FINAL ENVIRONMENTAL IMPACT STATEMENT

Hydroelectric Power Development

UPPER SUSITNA RIVER BASIN SOUTHCENTRAL RAILBELT AREA, ALASKA

DEPARTMENT OF THE ARMY
 ALASKA DISTRICT, CORPS OF ENGINEERS
 P.O. BOX 7002
 ANCHORAGE, ALASKA 99510

FIGURE 3
8

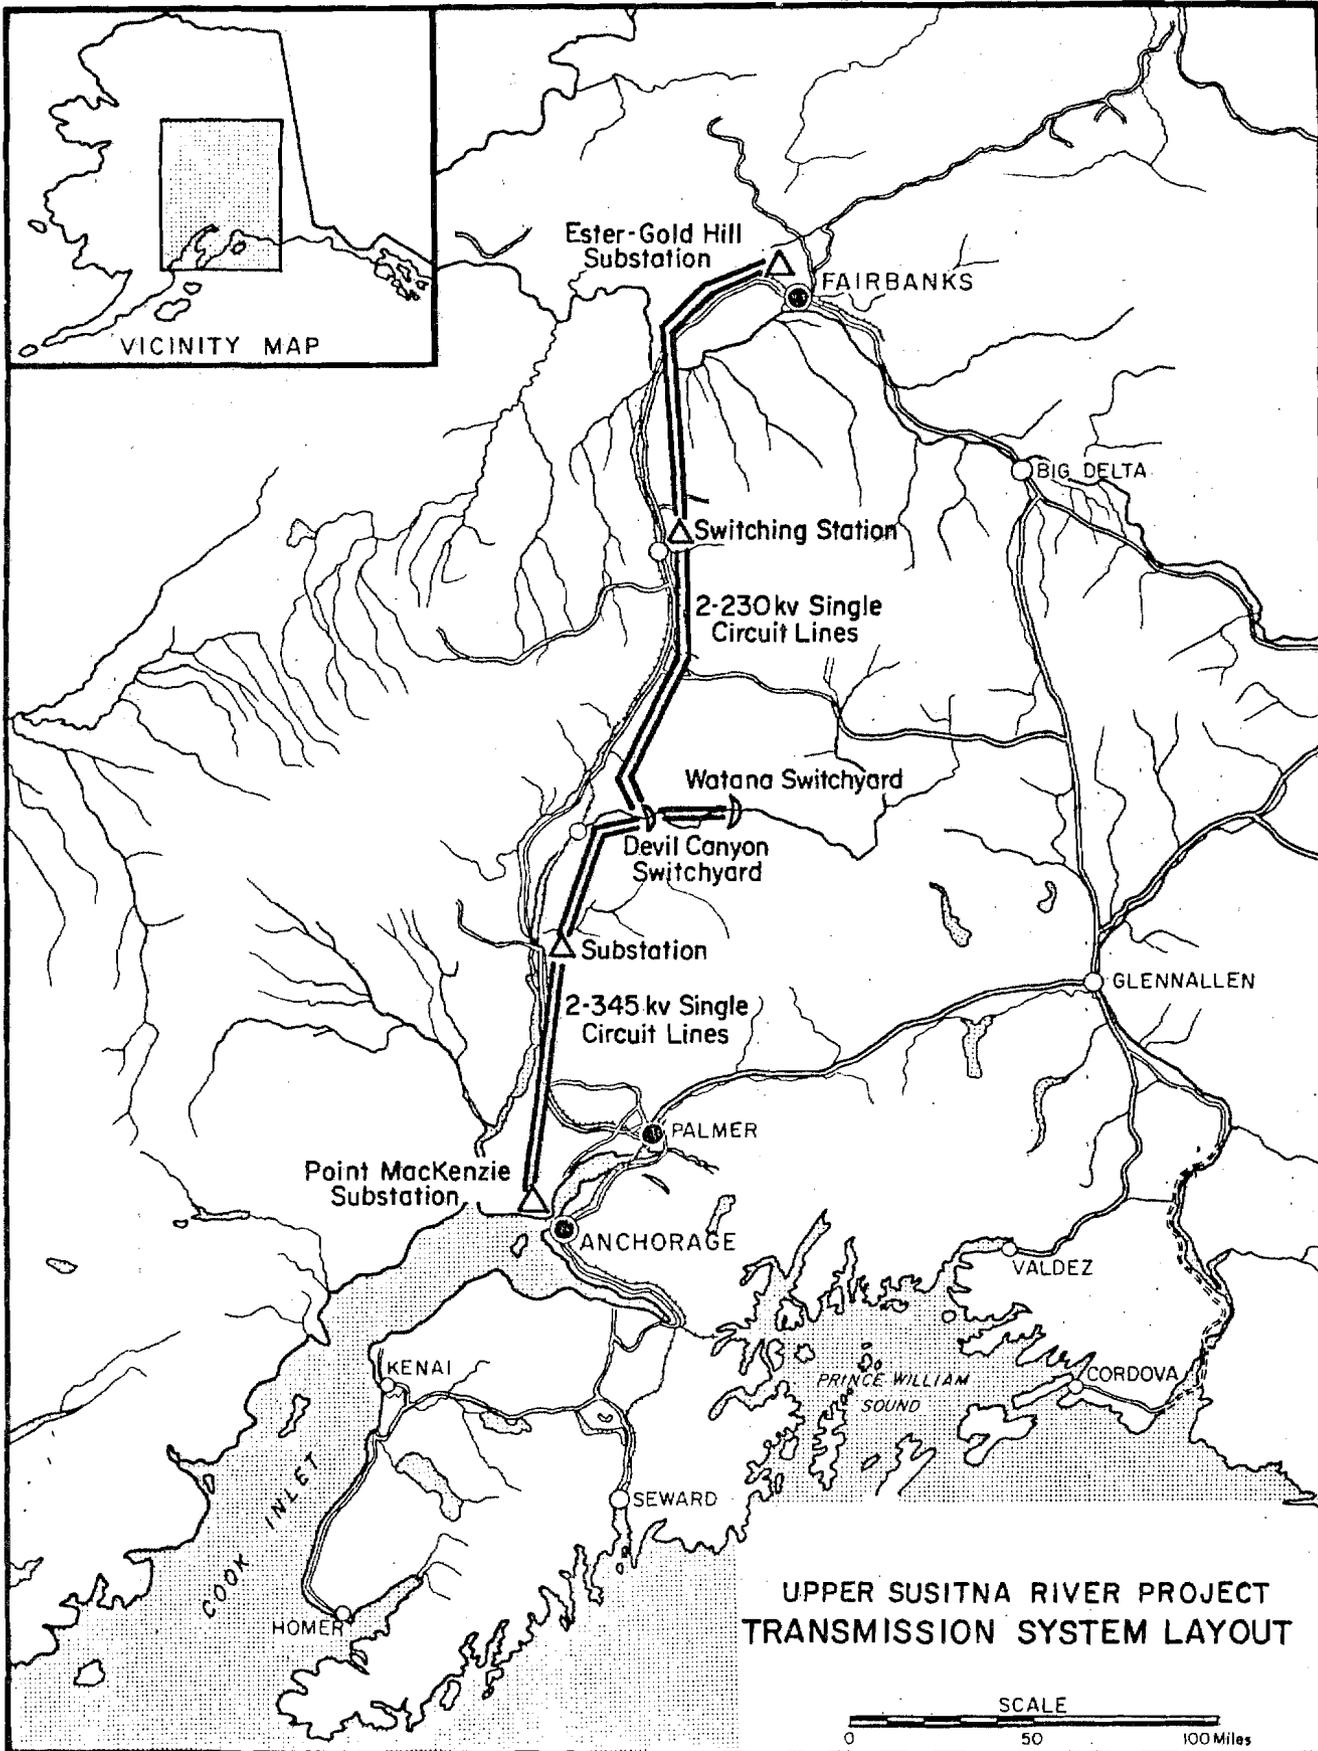
Figure 3 (page 7) is so sketchy as to be useless for assessing relationships between the transmission corridor and even basic terrain features. Figure 4 (page 11) is unreadable.

FIGURE 7

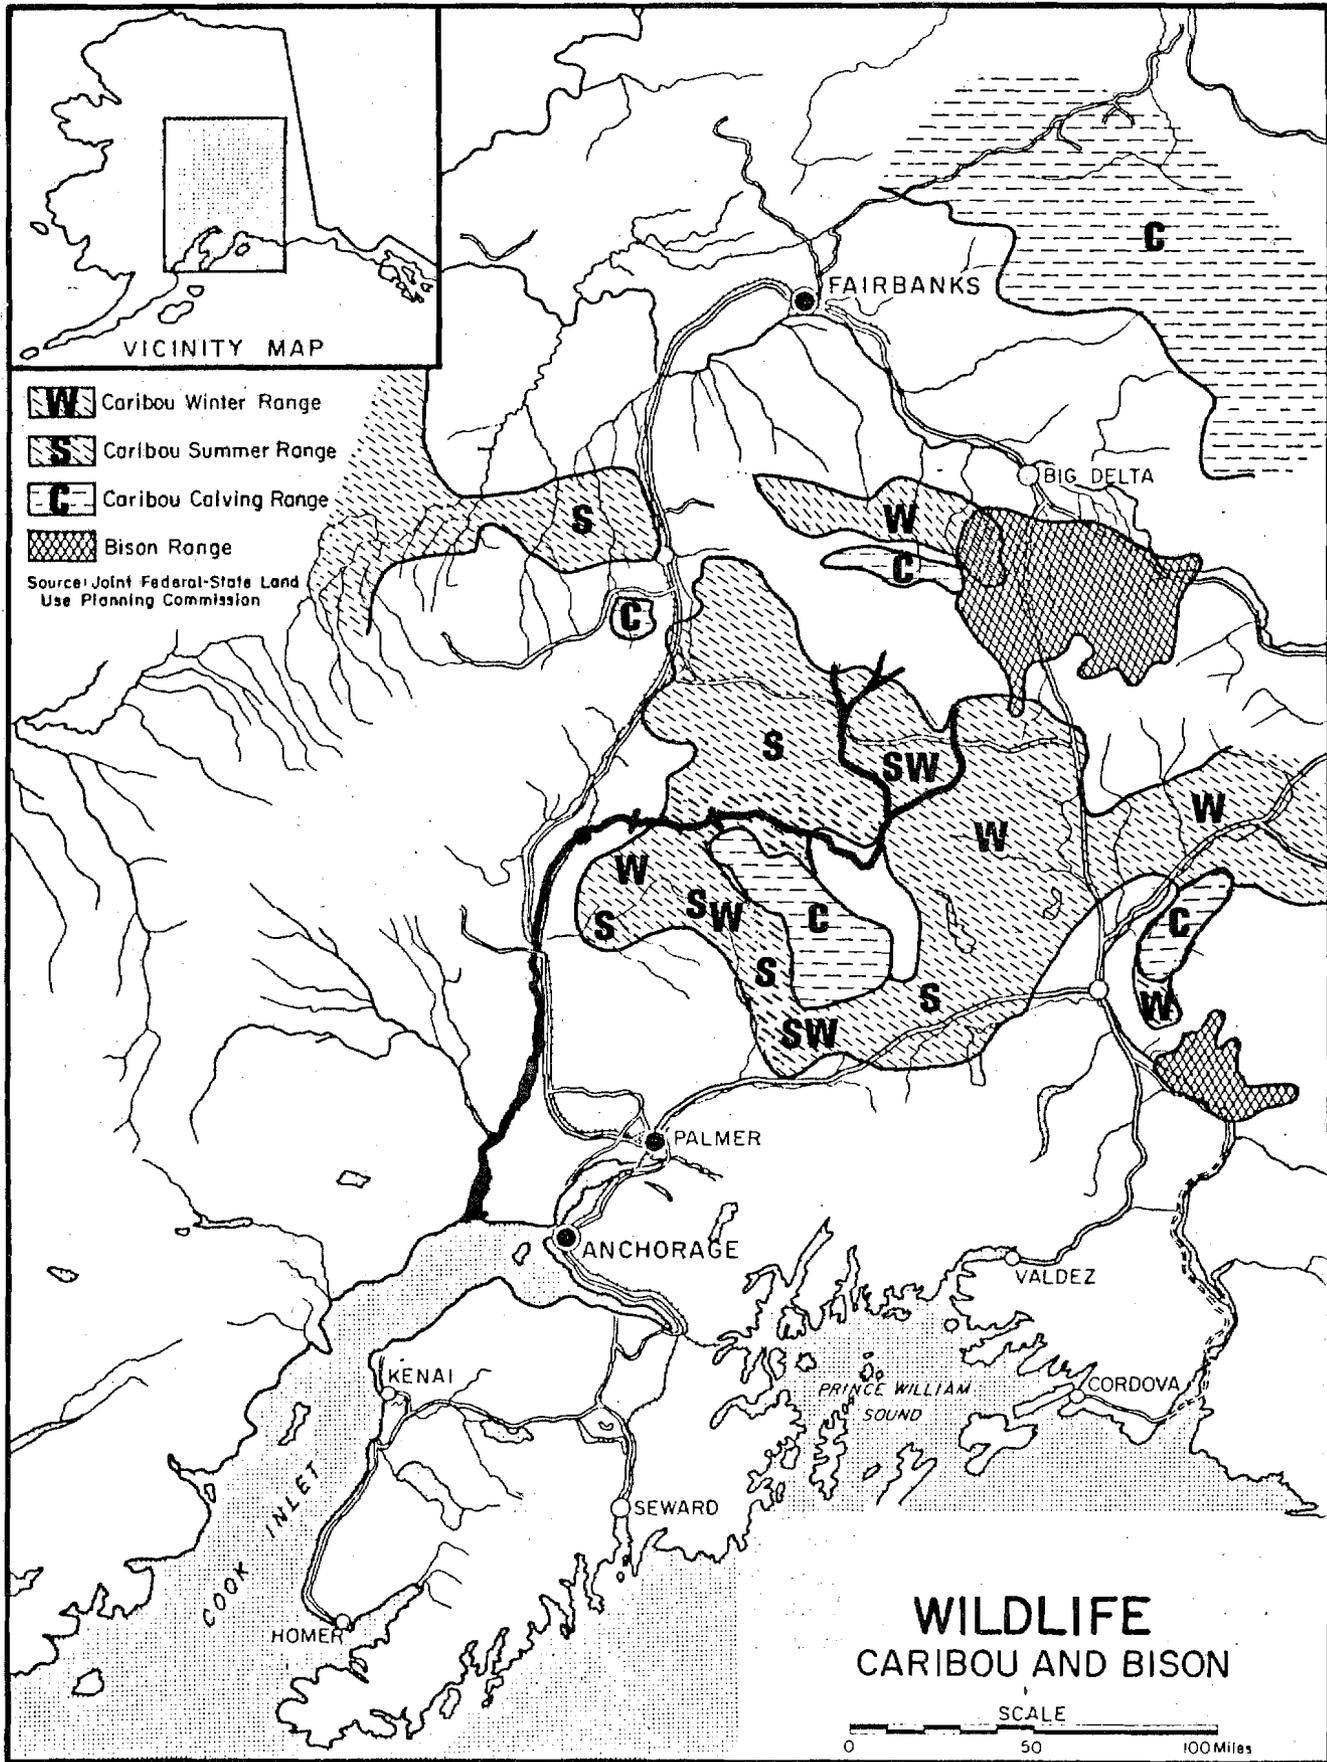
- 138 Page 24, Figure 7 - The white (unmarked) area in the center of the caribou range map is both summer and winter range. This area should be so indicated.

FIGURE 9

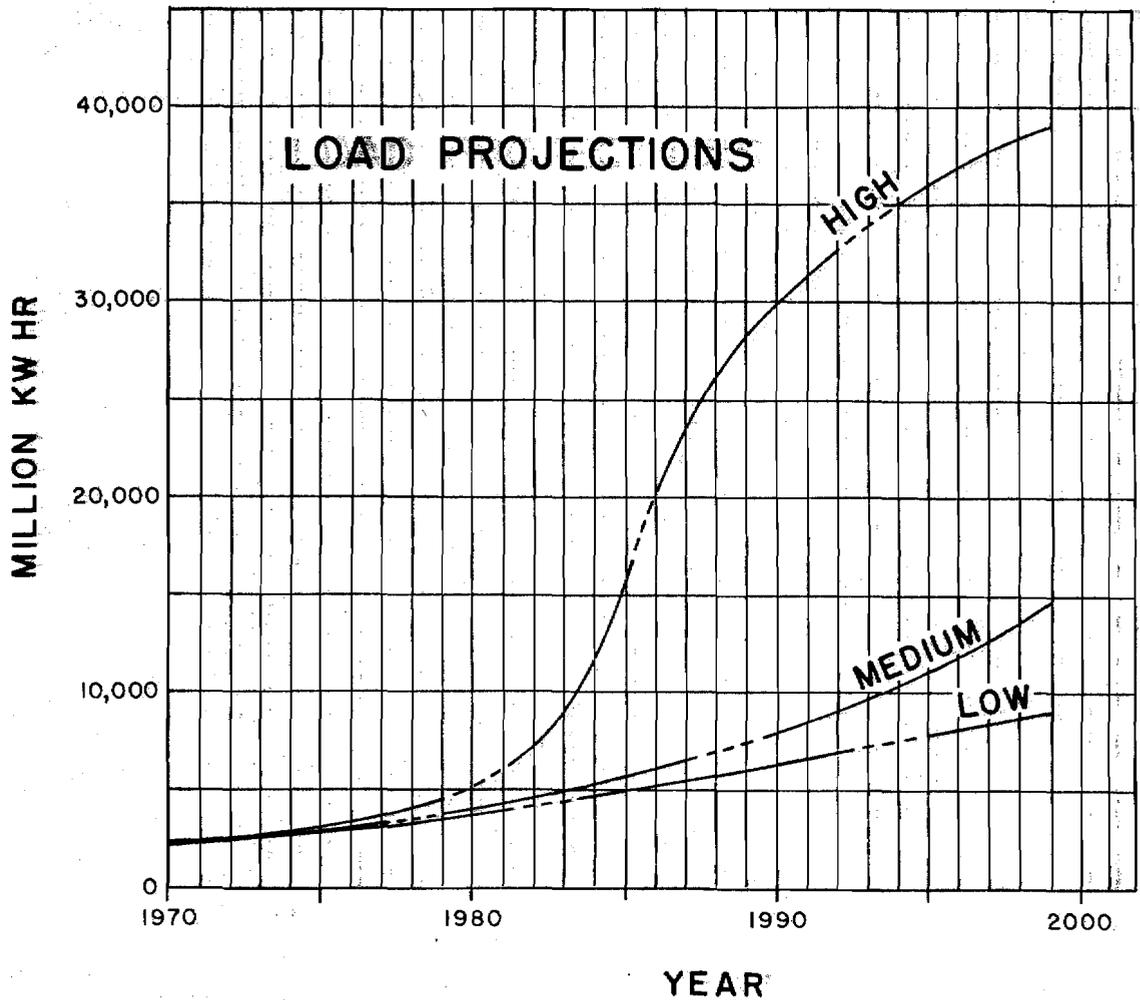
- 79** An entire section (2.04) is devoted to a discussion of energy needs. Figure 9 is a graph which illustrates a five-year record of energy consumption (1970-1974) plus projected load growth through the year 1999.

FIGURE 15

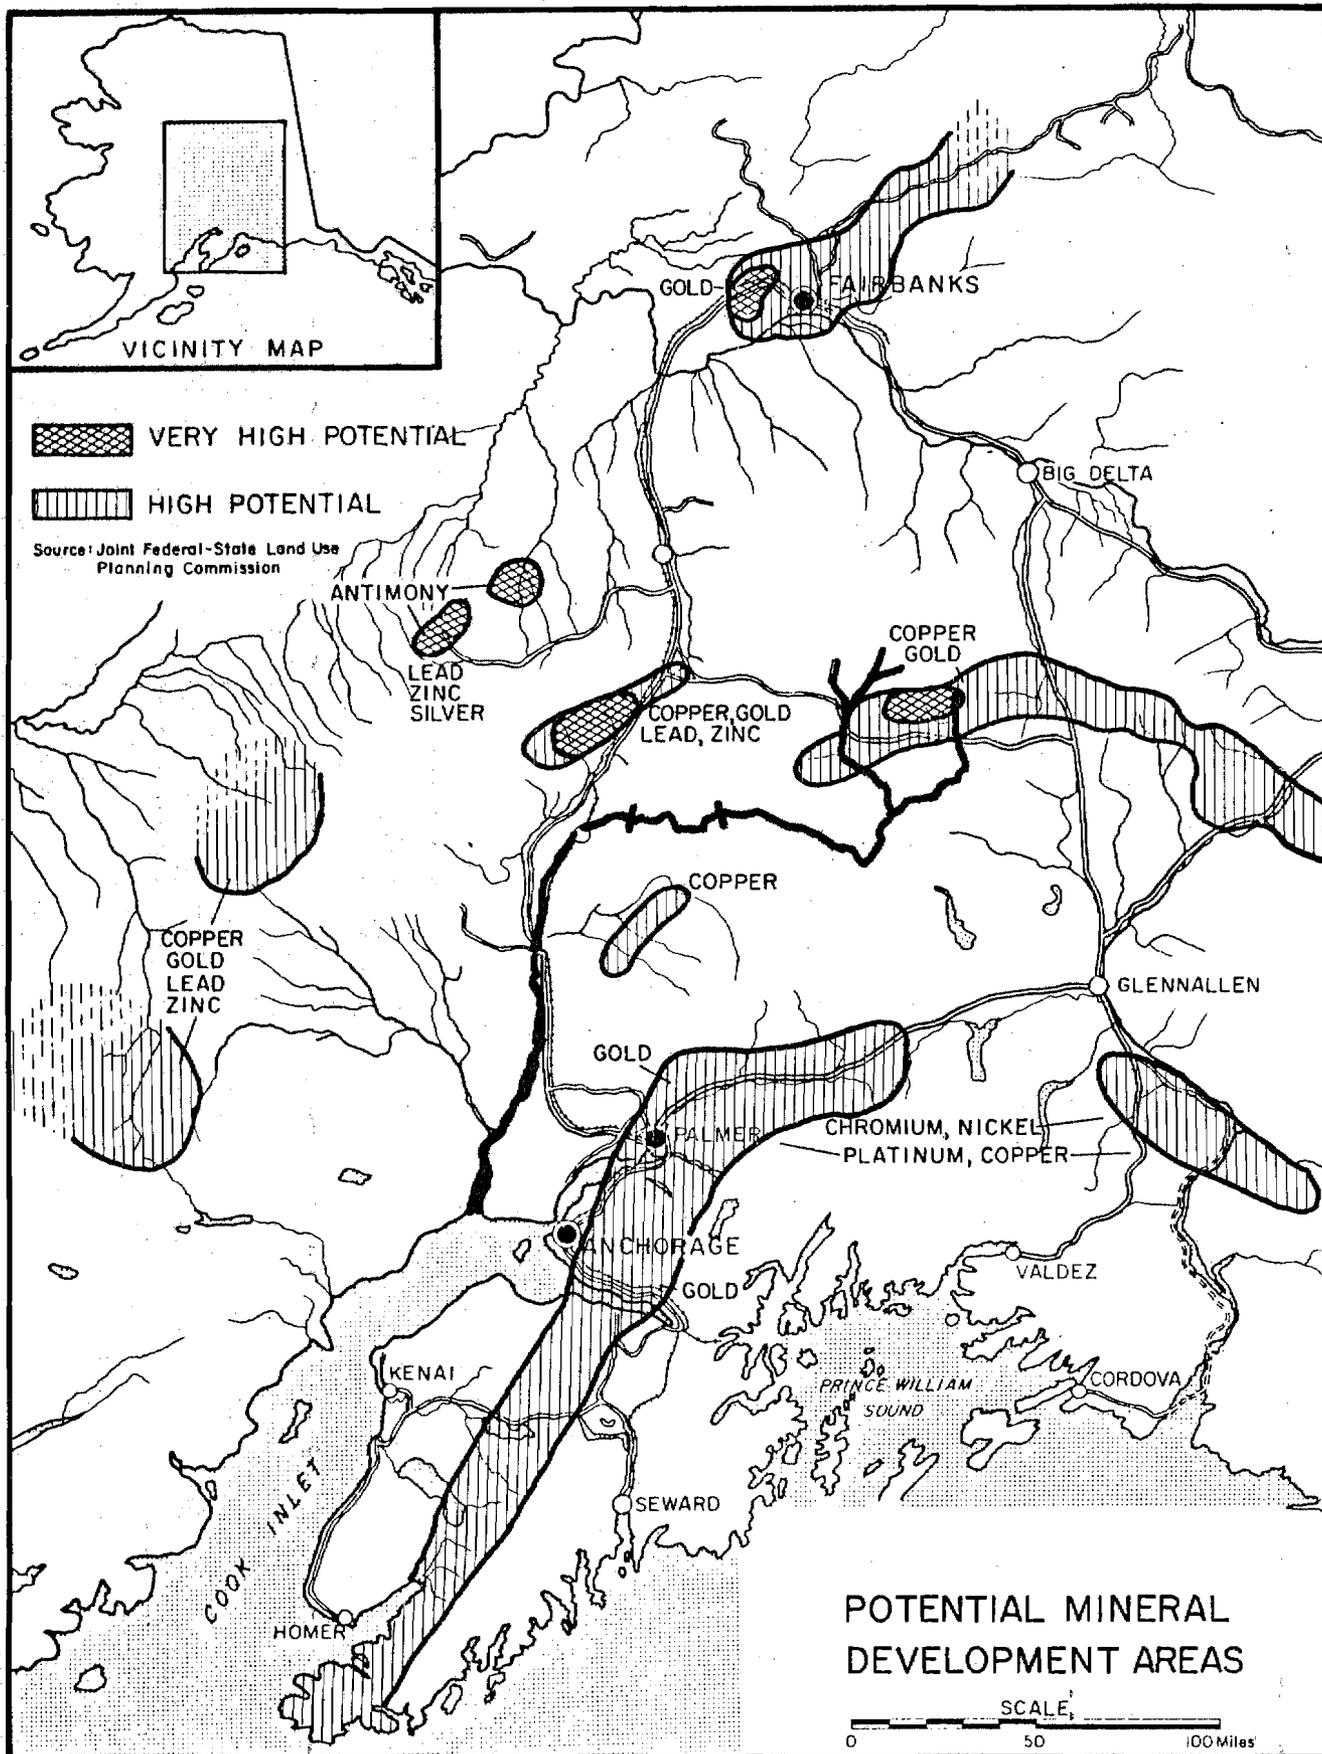
A transmission corridor is indicated in figure 15 as possibly passing through the Copper River Basin served by the Copper Valley Electric Association which has plans to increase their service by a new hydroelectric project at Solomon Gulch near Valdez with a transmission line to the Copper River Basin. The coordination of these two transmission or power systems should be explained in the final.

The second reason we consider the alternatives for power transmission corridors inadequate is that there is no analysis of impacts. Figure 15 graphically presents the alternatives. The text then states that the proposal was selected on the basis of cost, reliability, and potential environmental impact, but none of the needed information is presented. An environmental statement should present enough information for the reader to understand why the proposal was selected over the alternatives.
